December 5, 2023  
Subject: Bridge Deck Replacement  
State WIN: 025631.01  
Location: **Medway**  
**Amendment No. 9**

**REMOVE** Sheet Number 158 of 168, KEY PLAN & SHEAR CONNECTOR LAYOUT dated 10/3/2023 and **REPLACE** with the attached Sheet Number 158 of 168, KEY PLAN & SHEAR CONNECTOR LAYOUT dated 12/4/2023.

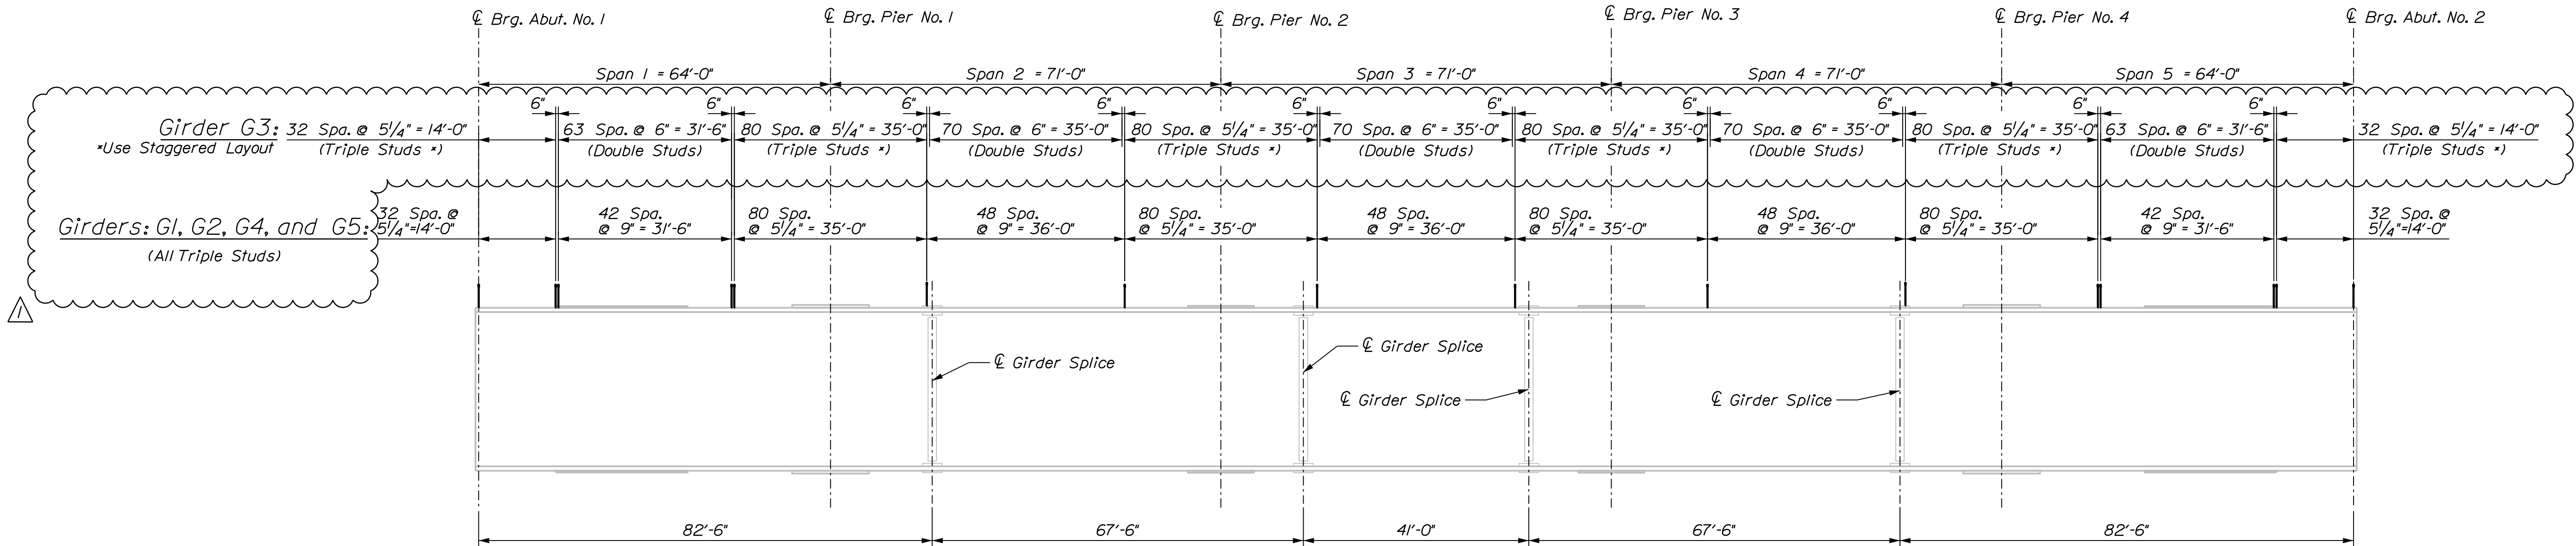
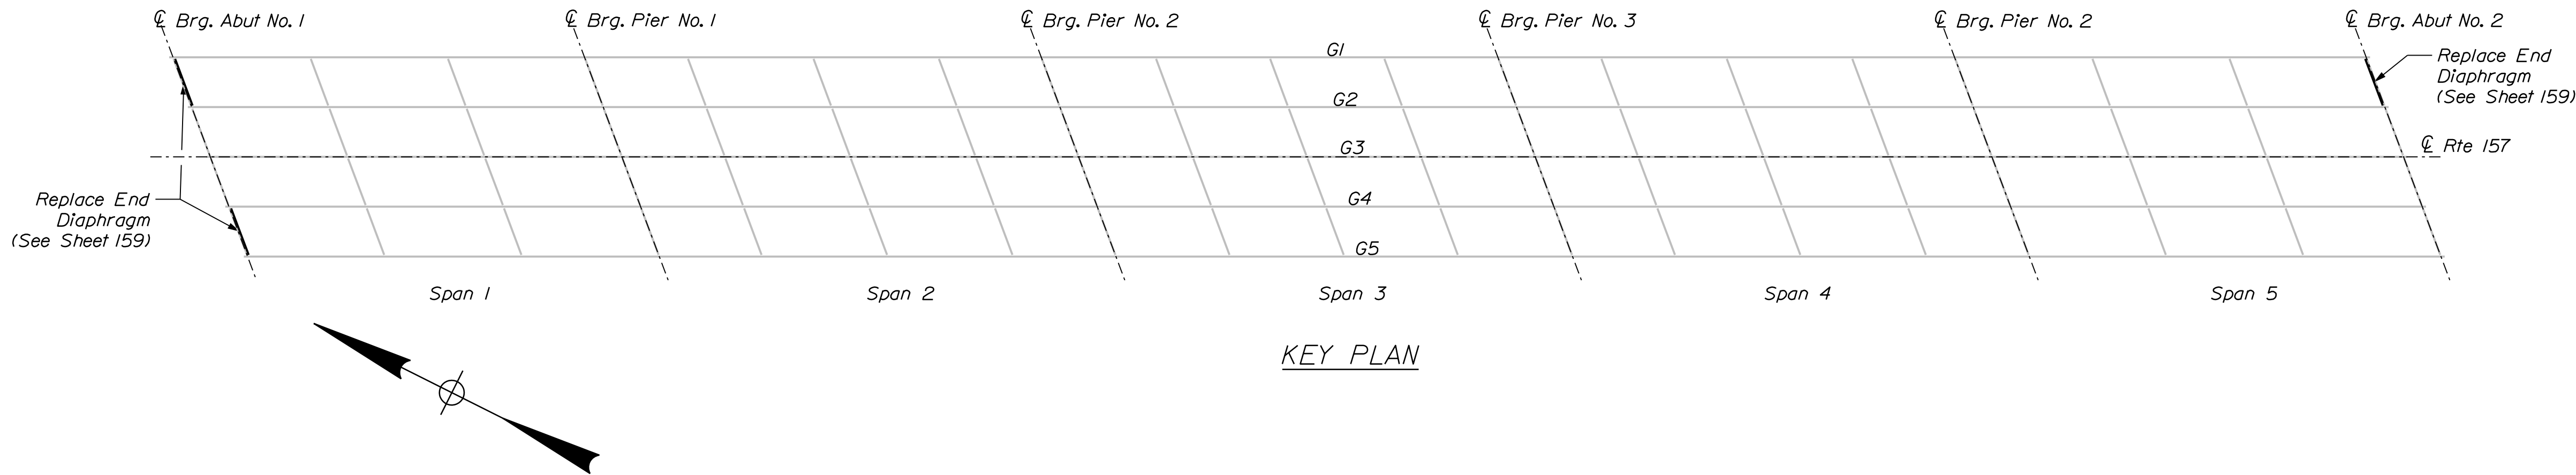
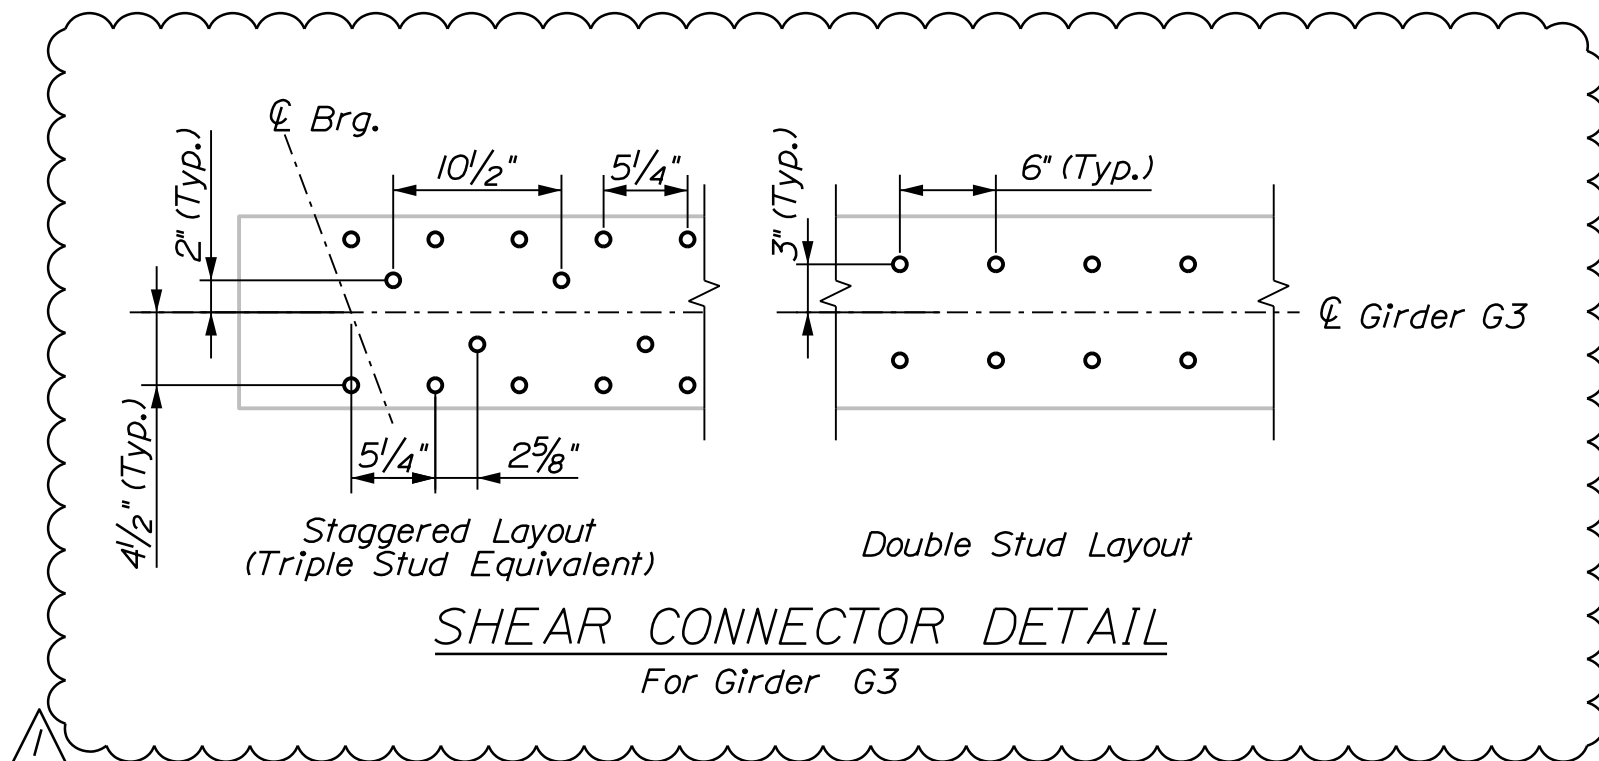
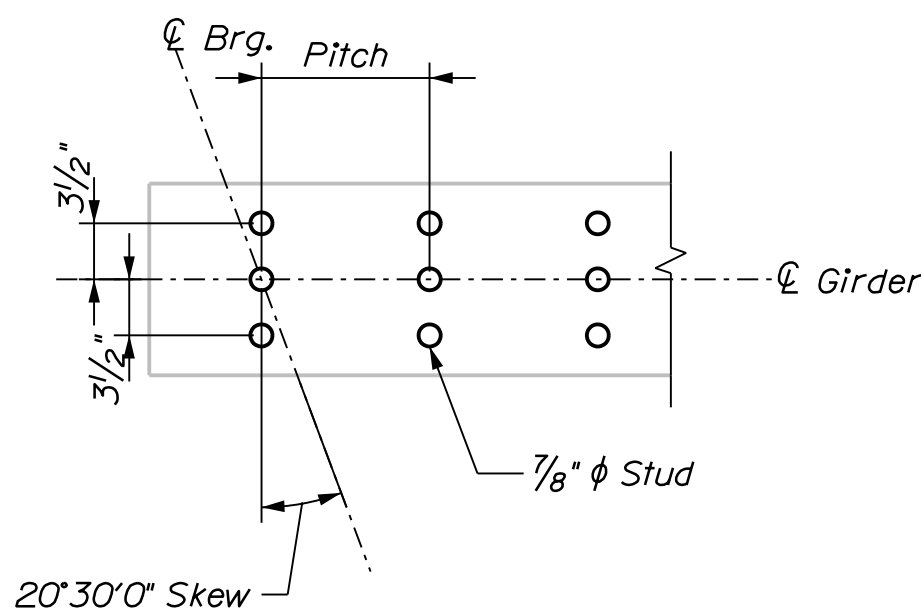
**Question:** On sheet 158 of the contract plans, the shear connector layout shows triple studs for the Route 157 Bridge. Is it possible to adjust the studs on G3 to a double stud layout to avoid interference with the construction joint located along the centerline of G3?

**Response:** See revised SHEET NUMBER 158 of 168, KEY PLAN & SHEAR CONNECTOR LAYOUT dated 12/4/2023. The total number of shear studs remains the same. The staggered layout for an equivalent of triple studs on Girder 3 avoids interference with the construction joint.
